**SINGAPORE CIVIL DEFENCE FORCE**

**Our Ref:** CD/04/05/01/01

**Date** : 1 Sep 2025

## **AMENDMENTS TO FIRE CODE 2023 – 4<sup>th</sup> BATCH OF AMENDMENTS**

**Revised Diagram 10.2.1d.: Roof-mounted PV Installations Criteria**

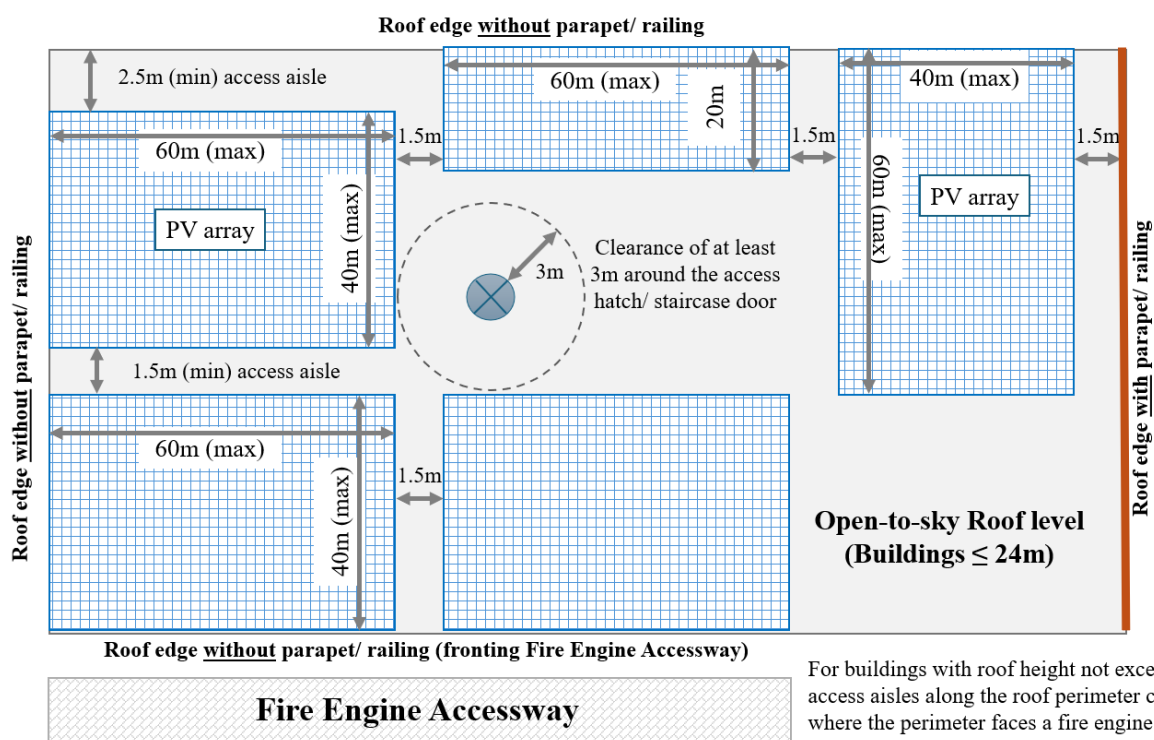
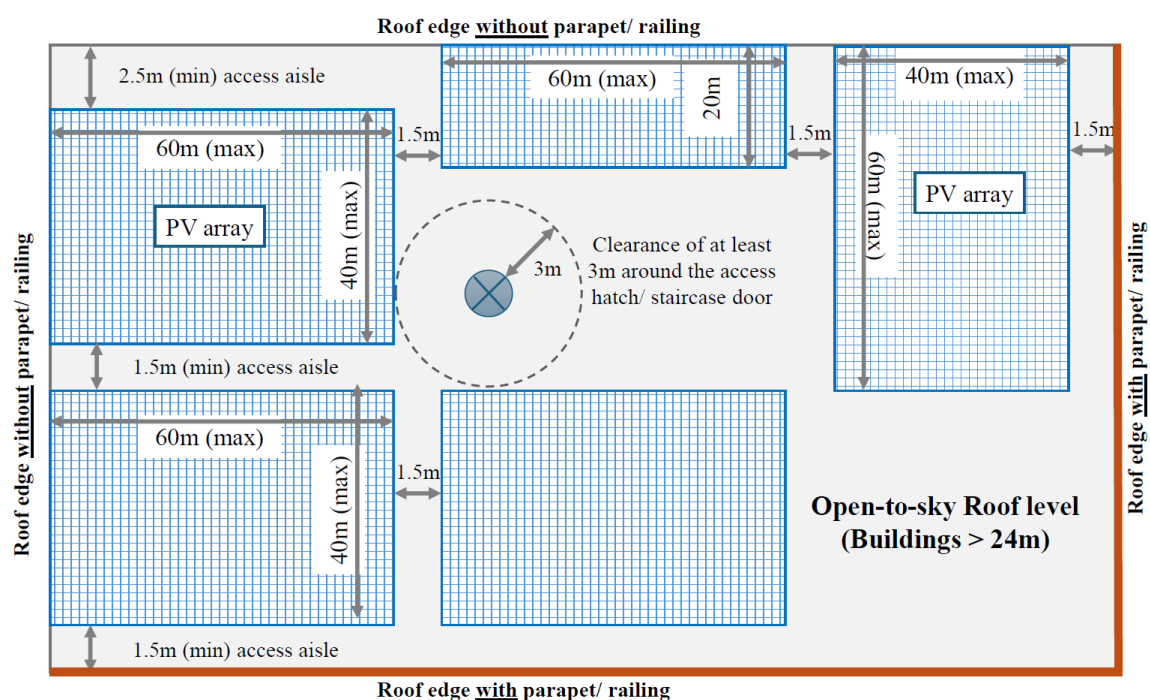
For buildings with roof height not exceeding 24m, access aisles along the roof perimeter can be omitted where the perimeter faces a fire engine accessway.
